TENNESSEE VALLEY AUTHORITY

In the Matter of the Application of) Docket Nos. 50-390
Tennessee Valley Authority) 50-391

ENCLOSURE
WATTS BAR NUCLEAR PLANT UNITS 1 AND 2
ANSWERS TO NRC CONCERNS WITH TVA's RESPONSE TO SORT FINDINGS

10 - Main Control Board

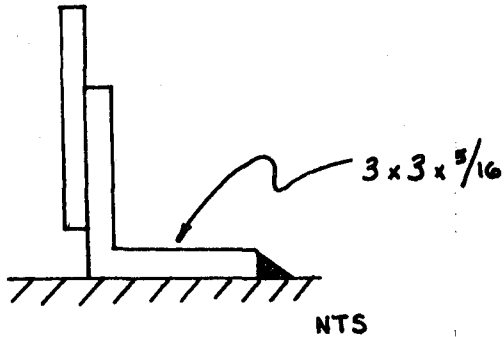
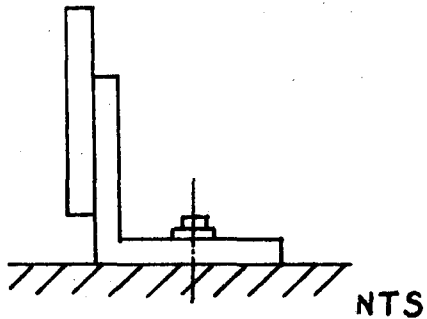
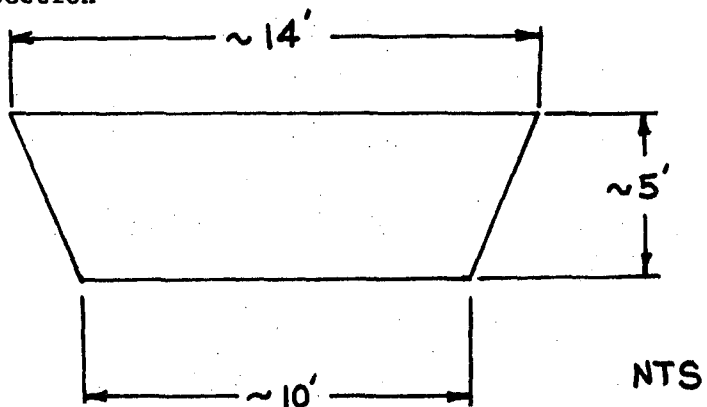
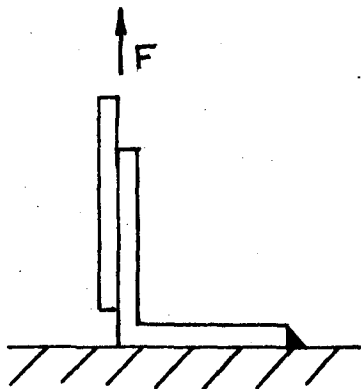
Provide calculations for the panel frequency shift from 21.1 Hz to 19.7 Hz due to base sill attachment difference between qualification and installed configuration.

The requested calculations are provided.

WBN Main Control Room Panel
"As-Qualified" Versus "As Installed"
Anchorage Flexibility

Assume no support from floor other than at weld or bolt locations as the conservative basis for comparison (i.e., effectively cantilevered from weld and bolt respectively.)

Qualified (bolted) configuration bending length is approximately 1/2 the installed (welded) bending length. Stiffness of qualified configuration is therefore 8 times as stiff as the installed configuration.

Total Effect: Effective base angle stiffness of bolted configuration is equal to twice that of welded configuration

The front/back natural frequency of the as qualified assembly configuration was 21.1 HZ.

$$= 19.7 \text{ HZ}$$

FIGURE-3-1

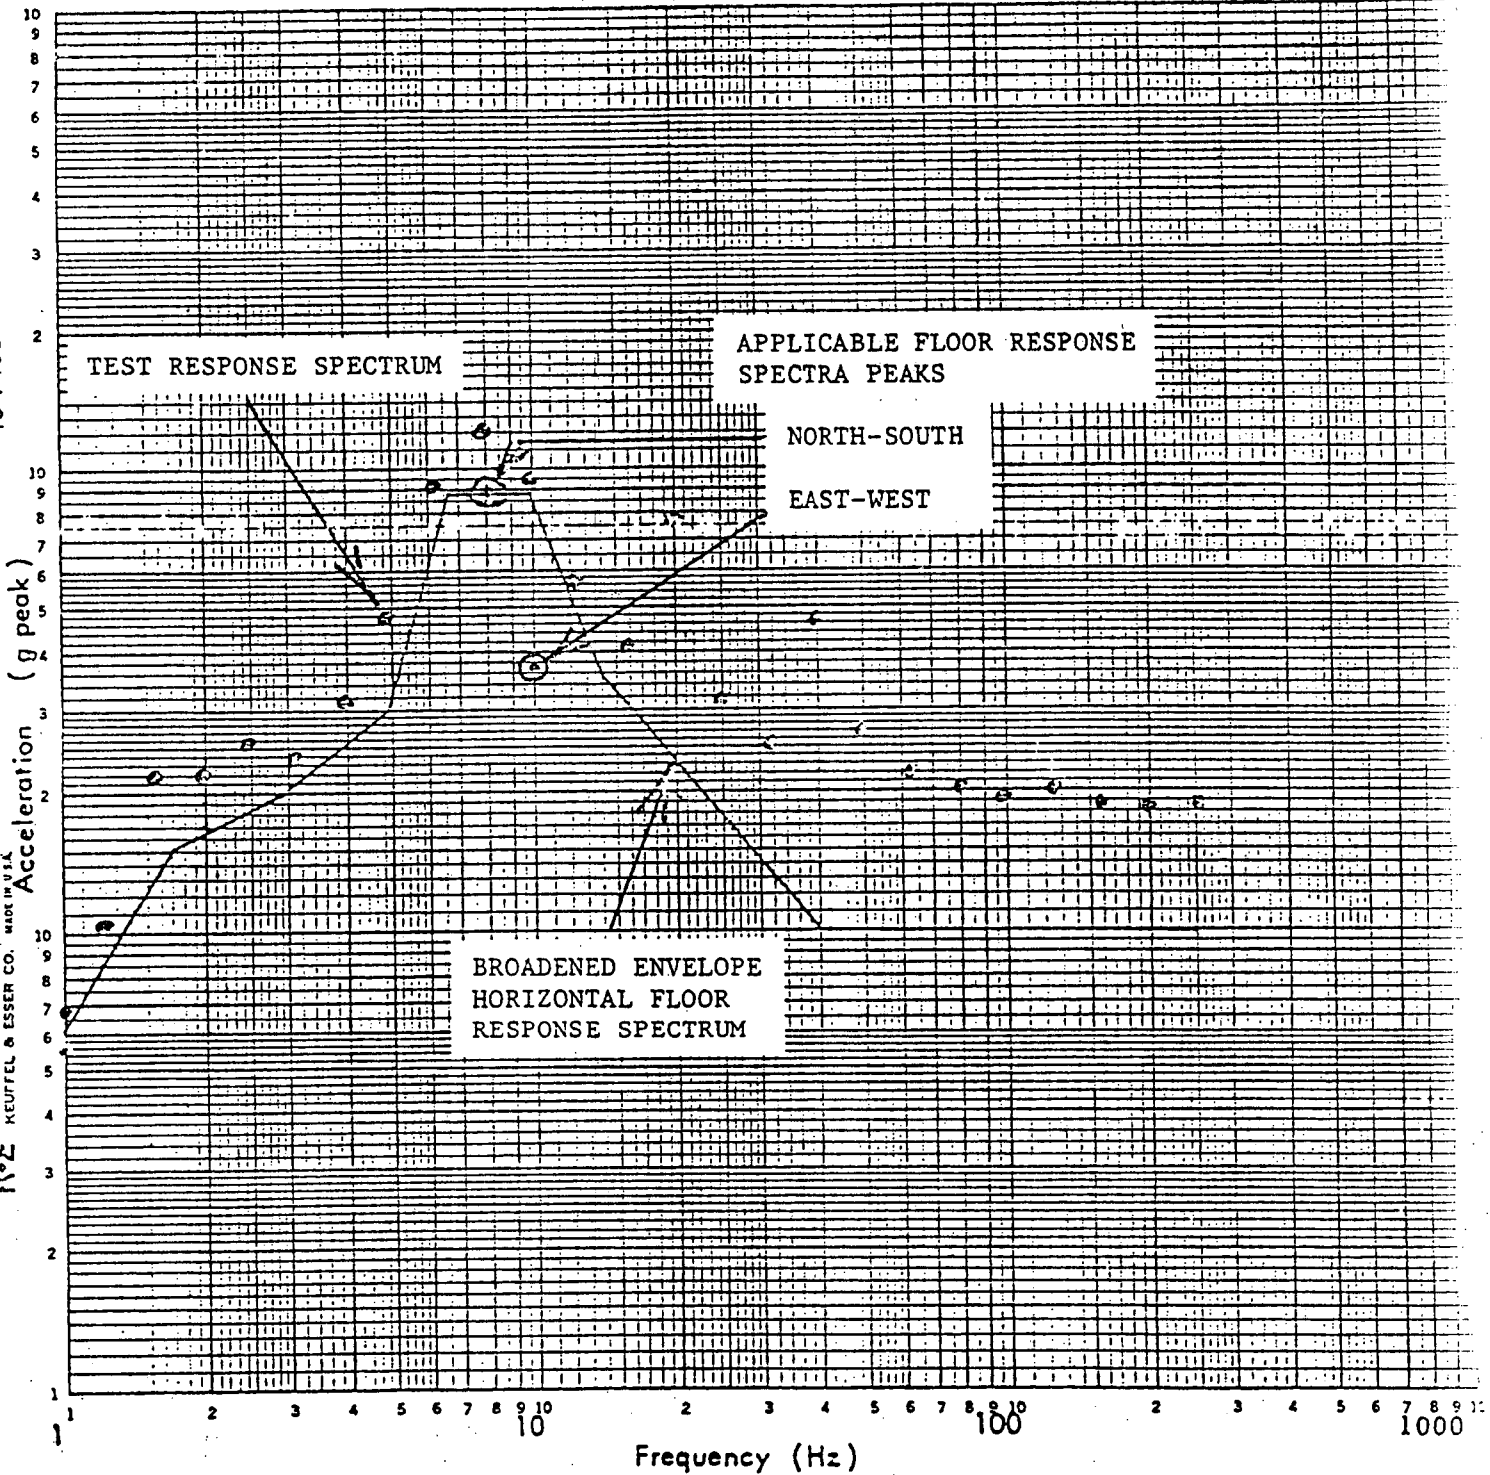
Provide statement regarding seismic response spectra peak broadening for Watts Bar equipment. Provide additional examples.

The seismic qualification of all Watts Bar safety-related equipment (BOP and NSSS) includes the consideration of response spectra peak broadening. In all cases, the applicable required response spectra is broadened, with respect to frequency, by at least ± 10 percent throughout the critical frequency range.

Qualification tests enveloping the broadened required response spectra is illustrated in the attached figures GC-3-1 through GC-3-8.

FIG 21.2-1

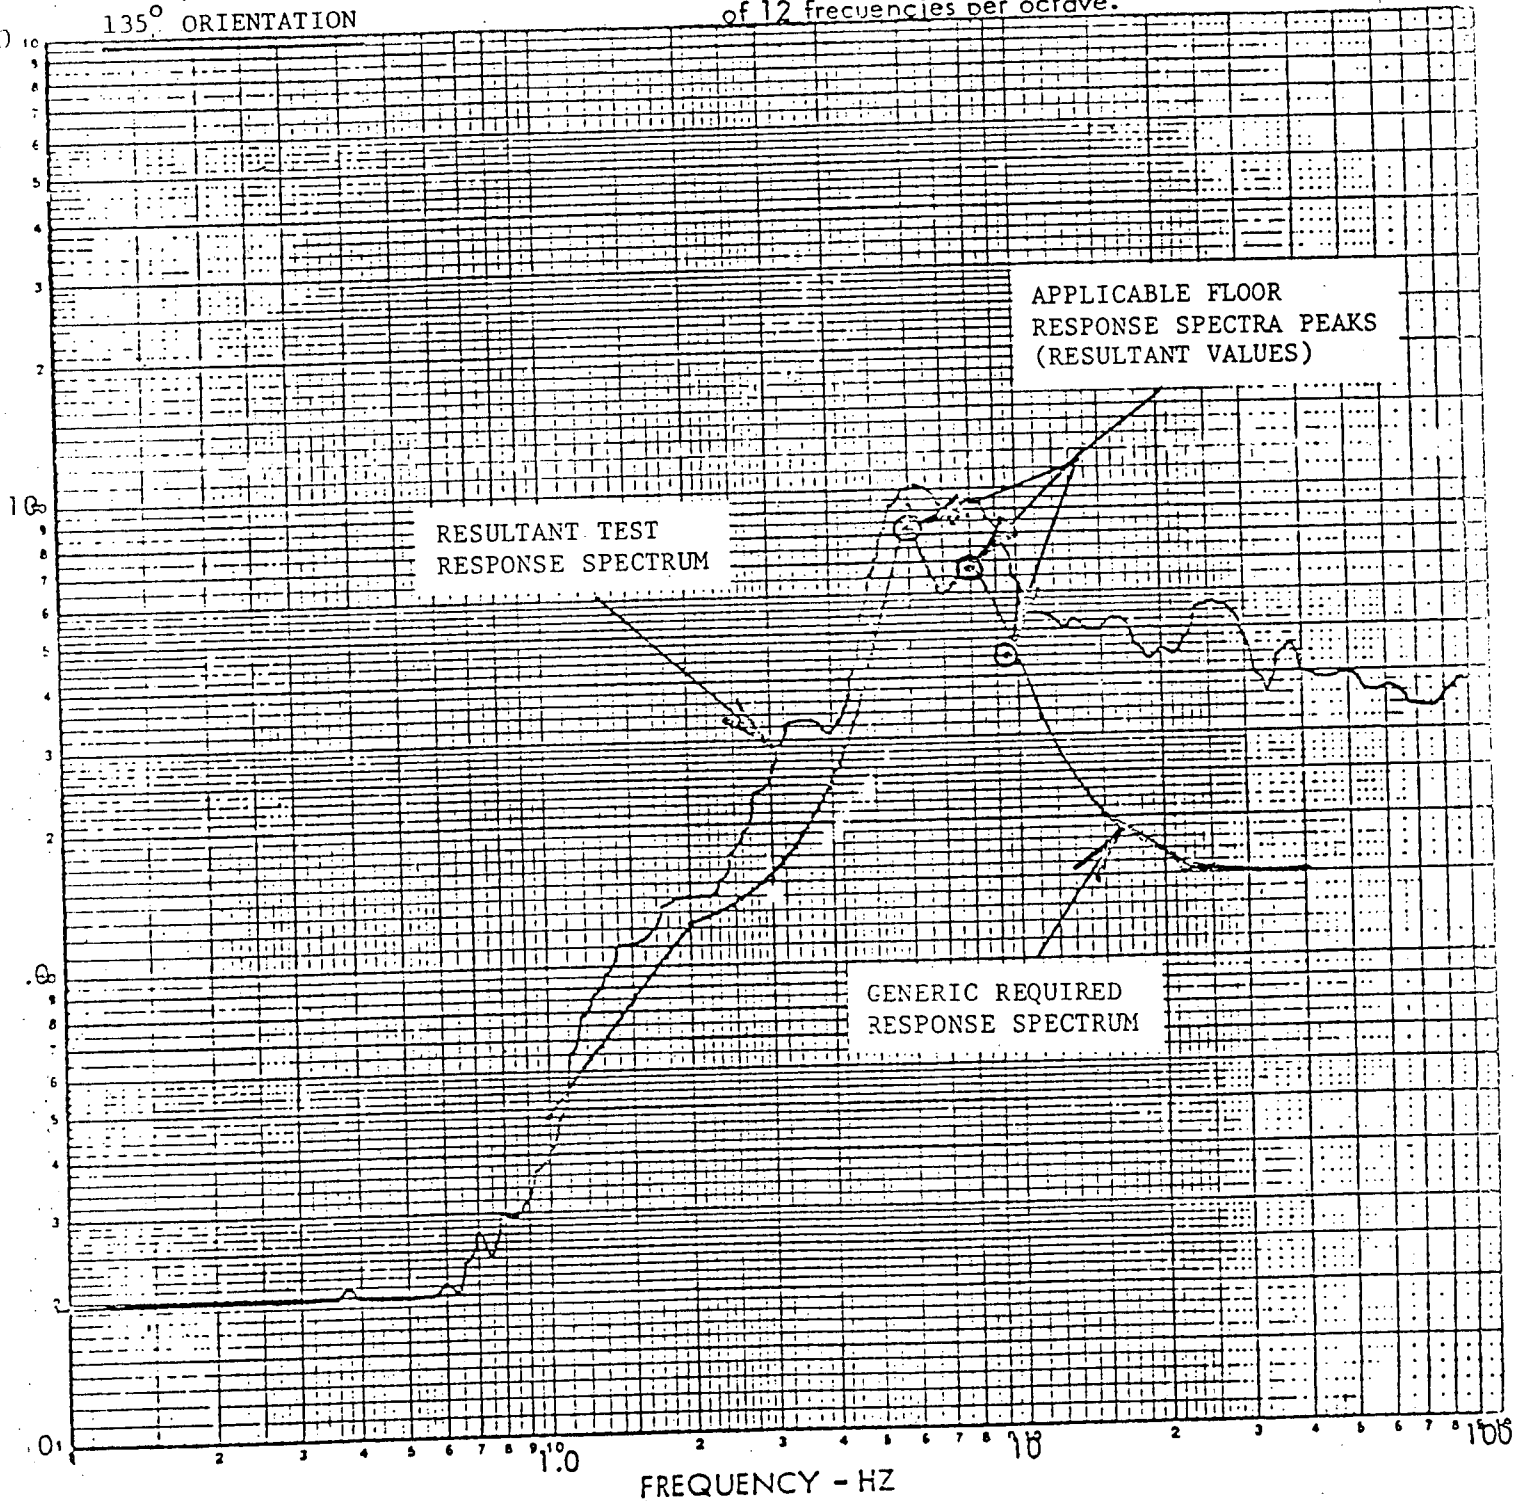
Illustrate the comparison of the test response spectra (TRS) with the required response spectra (RRS) for the Barksdale pressure switch.

As discussed in detail in the previous submittal, the switch was subjected to a series of single frequency tests at observed natural frequencies. The attached plot (fig. 21.2-1) represents typical comparison of TRS and RRS. Note that at the most critical frequencies (observed natural frequencies), the TRS exceeds the RRS.
